Third amendment of the Day-Ahead Capacity Calculation Methodology of the Core Capacity Calculation Region

in accordance with Articles 20ff. of the Commission Regulation (EU)
2015/1222 of 24th July 2015 establishing a guideline on capacity allocation
and congestion management

8th December 2023

Figure 1: Determination of external constraints in export direction (generating capacities available for potential exports) in the framework of the day-ahead capacity calculation.

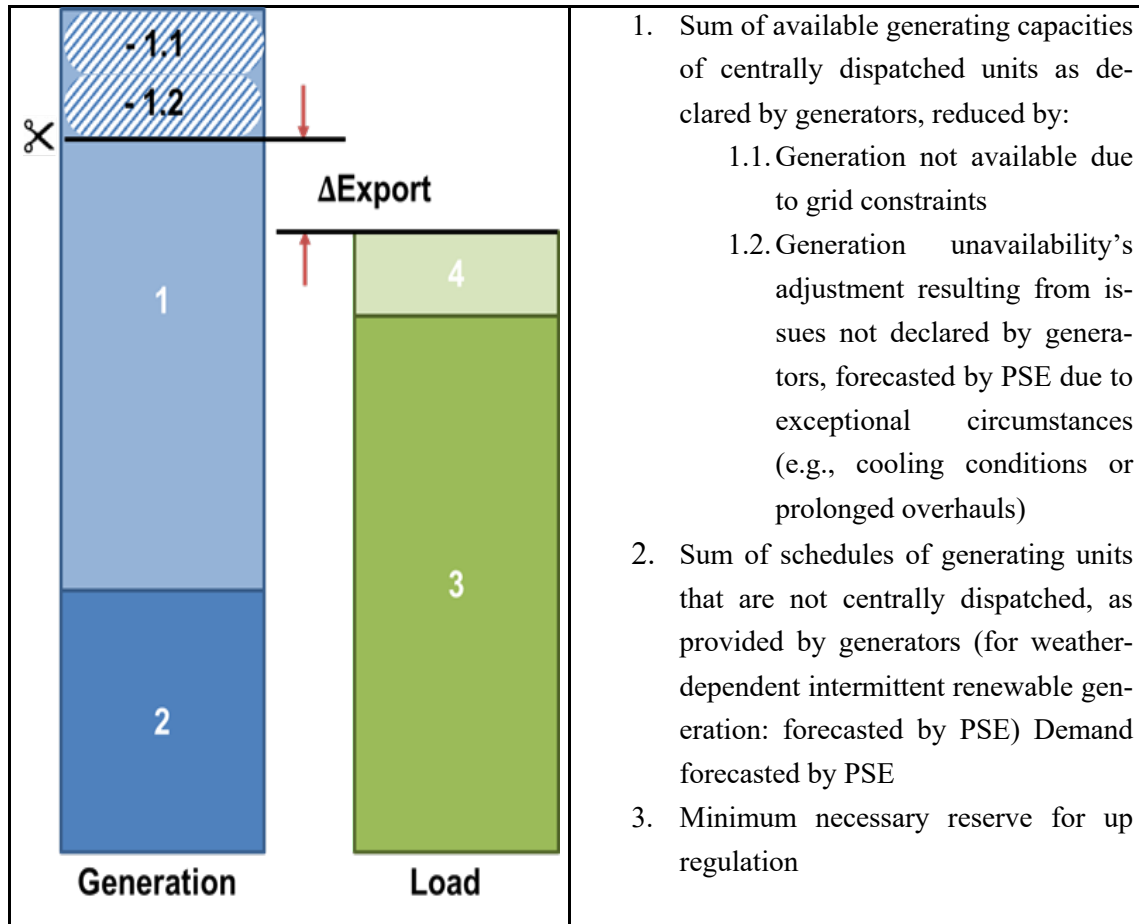
Text of the Annex 1 shall be replaced and be read accordingly:

For illustrative purposes, the process of practical determination of external constraints in the framework of the day-ahead capacity calculation is illustrated below in Figures 1 and 2. The figures illustrate how a forecast of the Polish power balance for each hour of the delivery day is developed by PSE in the morning of D-1 in order to determine reserves in generating capacities available for potential exports and imports, respectively, for the day-ahead market.

External constraint in export direction is applicable if D_{Export} is lower than the sum of cross-zonal capacities on all Polish interconnections in export direction. External constraint in import direction is applicable if D_{Import} is lower than the sum of cross-zonal capacities on all Polish interconnections in import direction.
